**REQUEST FOR ADDITIONAL INFORMATION (RAI) REGARDING BEAVER VALLEY UNIT Nos. 1 AND 2 LICENSE AMENDMENT REQUESTS Nos. 334 (UNIT 1) AND 205 (UNIT 2) :**

Note: The following responses are applicable to Beaver Valley Unit 1 only.

Figure 1

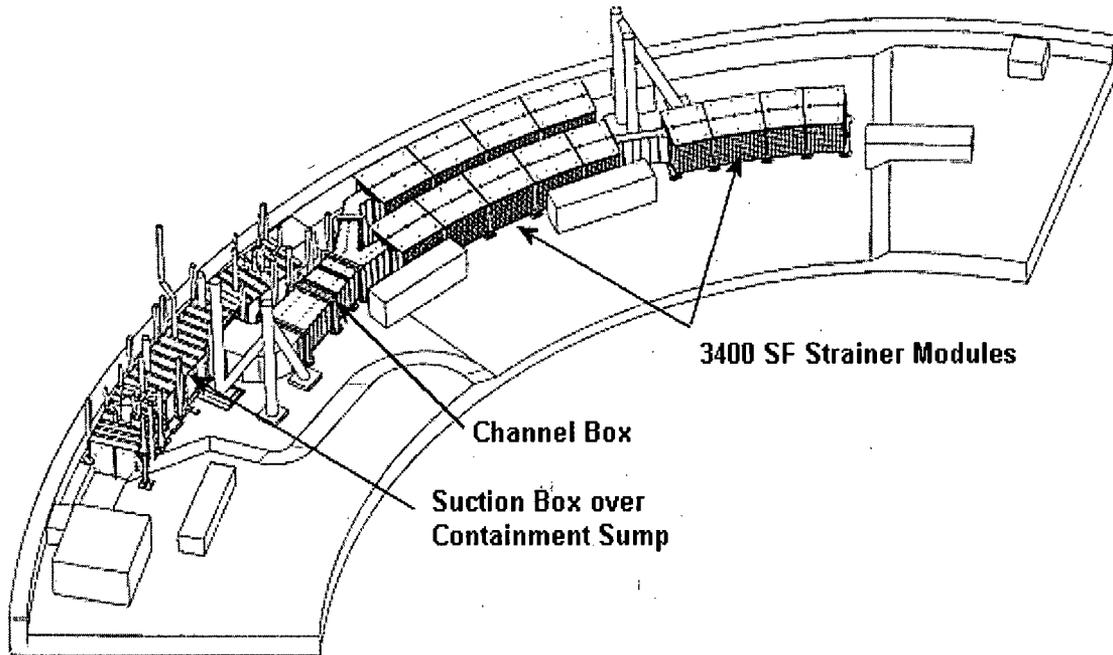
2. Provide a simple sketch of the layout showing the arrangement for the modified containment sump strainer assembly.

A simplified sketch is provided as Figure 1.

**BEAVER VALLEY UNIT 1 CONTAINMENT SUMP STRAINER ASSEMBLY LAYOUT**
